Memo

SLP REV. 1 to SLP REV. 2

Date: April 25, 2016 **UBC Gage South** Re:

GAGE SOUTH EXCHANGE PHASE 1 - UNDERGROUND WORKS

C 27E

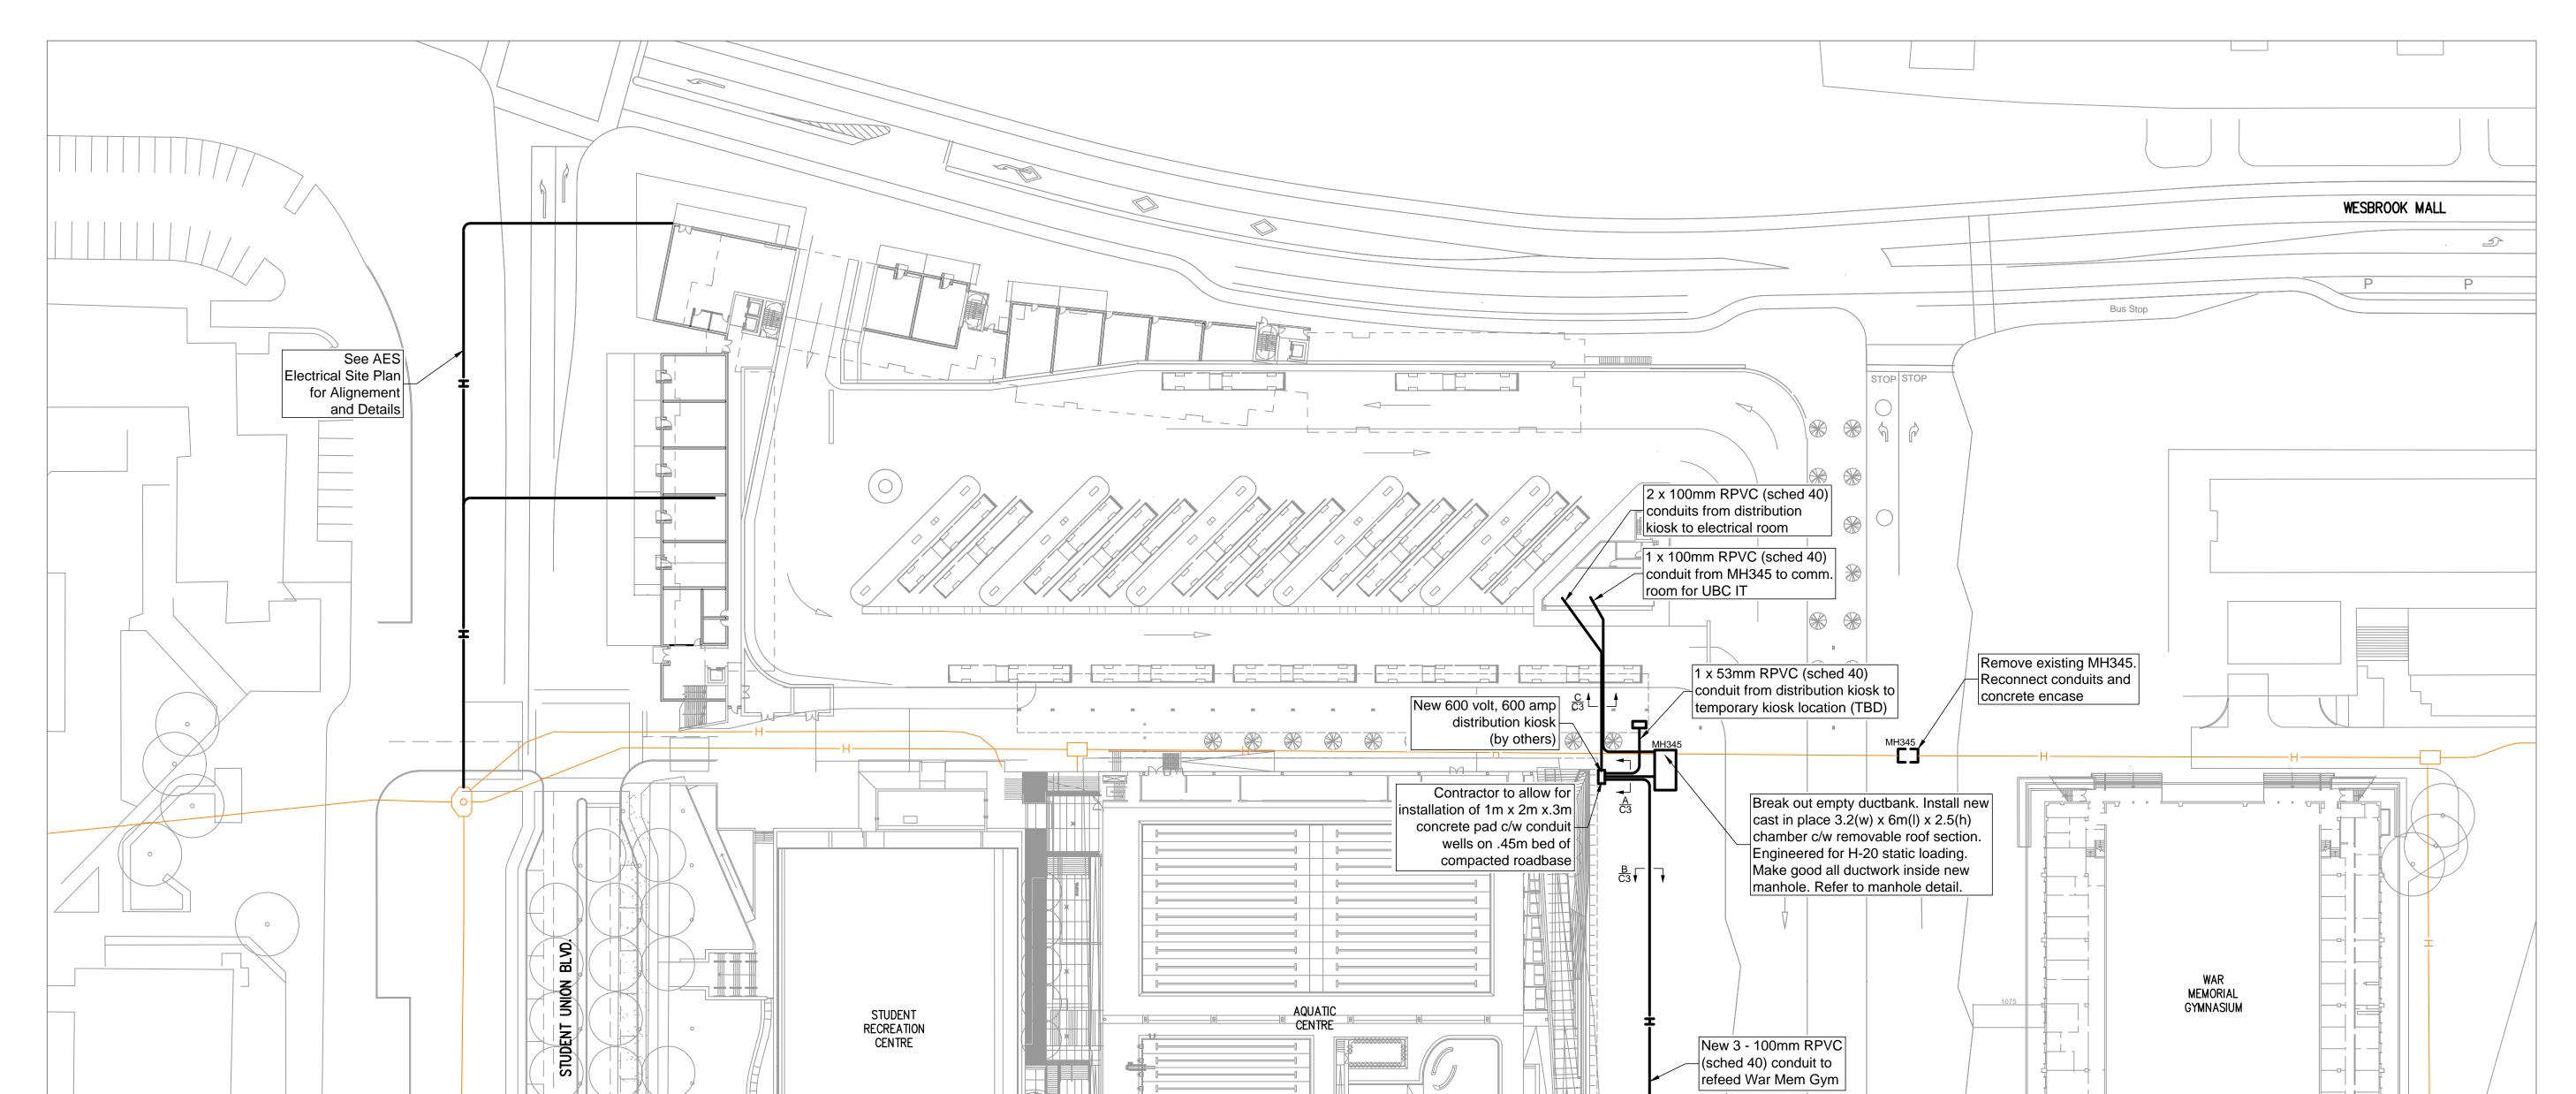
C27E - Utilities, Plan/Profile Phase 1 Water

- Water Connection and Hydrant Location Adjusted
- 2) Water Service Building Entry Detail Added

Civil Design ELECTRICAL SITE SERVICING PLAN

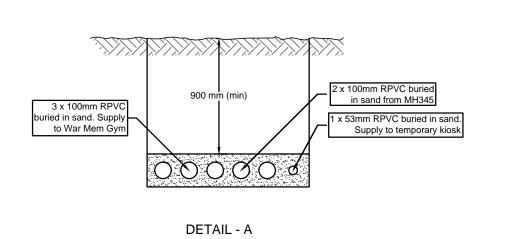
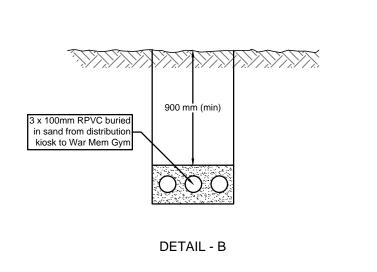
H1 – Electrical Site Servicing Plan

1) Hydro Conduit, kiosks, and Chambers Updated to UBC and AES Comments
